PLATTE RIVER POWER AUTHORITY'S ZERO NET CARBON ANALYSIS

*A Critique of the Pace Global Report and
Recommendations for Future Analysis*

Colorado Sierra Club
Northern Colorado Partners for Clean Energy

March 30, 2018

Figure 1: Henry Hub Forward Prices: Platte River Data and Current CME Data

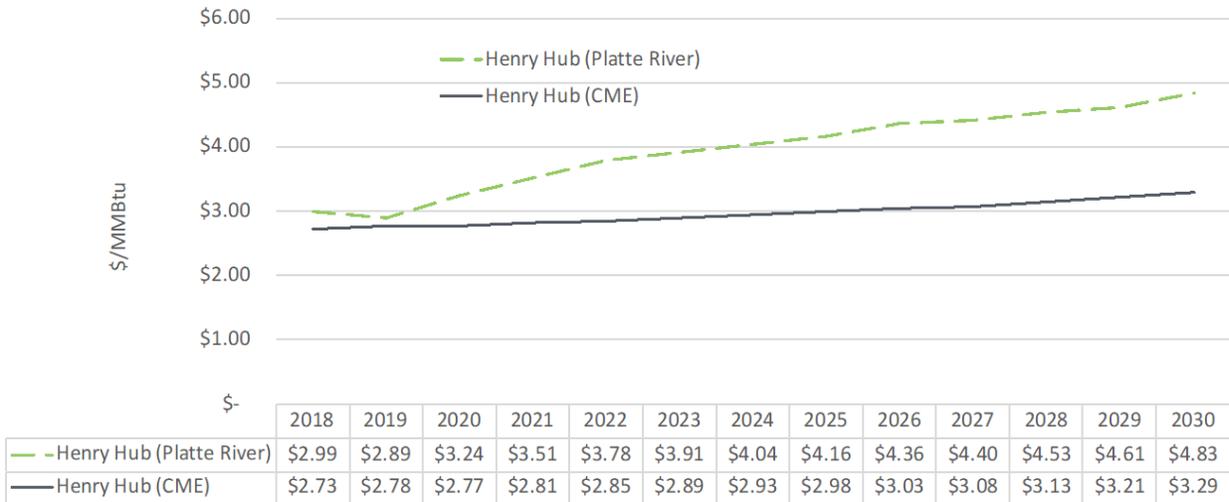
Second, the Henry Hub price forecast utilized in the ZNC Analysis appears to be quite high compared with recent price forecasts Energy Strategies has tracked in the wholesale gas markets. Figure 1 shows the Henry Hub price curve from the Platte River data (received in mid-January 2018) and the Henry Hub forward prices as of February 13, 2018 as published by CME.⁴⁹

prices for the same year. Forward prices do differ on a daily basis, however the reason for the difference between the two price forecasts cannot be explained from the information provided by Platte River.

- Natural gas price projections should account for the uncertainty of natural gas markets. Platte River should include low and high natural gas price forecast sensitivities in addition to its base price assumptions in its resource planning assessments.

Figure 2: Platte River Basis plus Delivery Costs

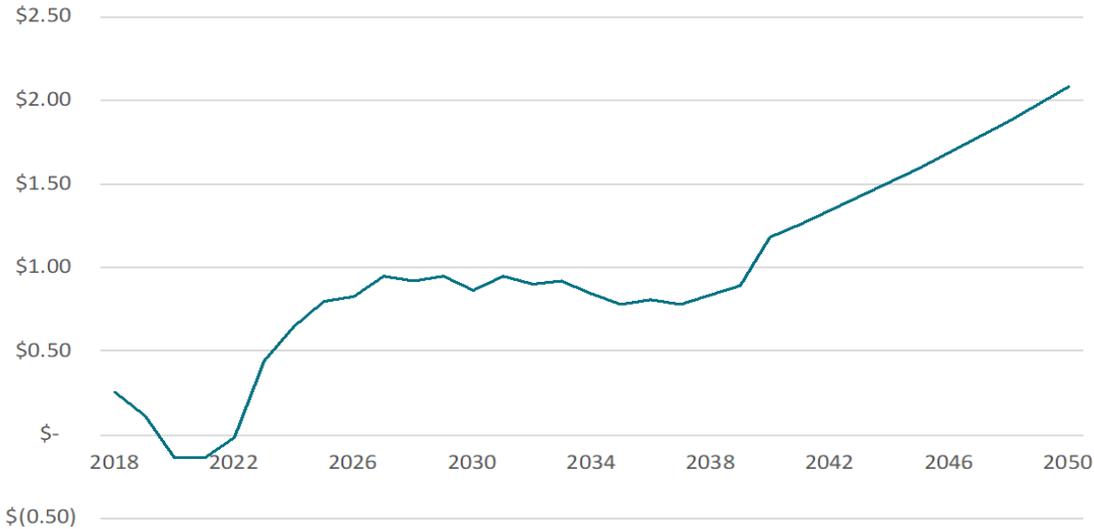
In addition to the Henry Hub natural gas commodity price forecast appearing to be high, the “delivered” price of natural gas to Platte River appears to be high, too. The “delivered” natural gas price is composed of the price paid for the natural gas commodity and the costs associated with delivery of the gas to a location, in this case, Platte River. The costs include the basis differential, pipeline transport costs, delivery costs charged by the local natural gas distribution company and other transaction-related costs. Platte River’s forecasted gas prices show that the basis differential and non-commodity price components would contribute over 15% to Platte River’s total delivered cost of gas. As previously discussed, the data received from Platte River combined all price components into a “Delivered Platte” price which does not separately define all non-commodity price components. Annual basis plus delivery can be calculated by subtracting the Platte River Henry Hub price for each year from the Delivered Platte price for each year. Figure 2 illustrates the calculated basis plus delivery price components for each year of the forecast.

The large percentage variations in the early years of the forecast cannot be explained with the available data. Over the forecast period, basis plus delivery increases by 183%, averaging 5.4% each year. Generally, basis differential does not vary significantly over time and transportation and local distribution company rate regulation do not increase 5.4% every year. An average annual escalation rate nearer the rate of inflation, i.e. 2%, would be a more appropriate escalation rate for the basis plus delivery price components of the natural gas price assumption.
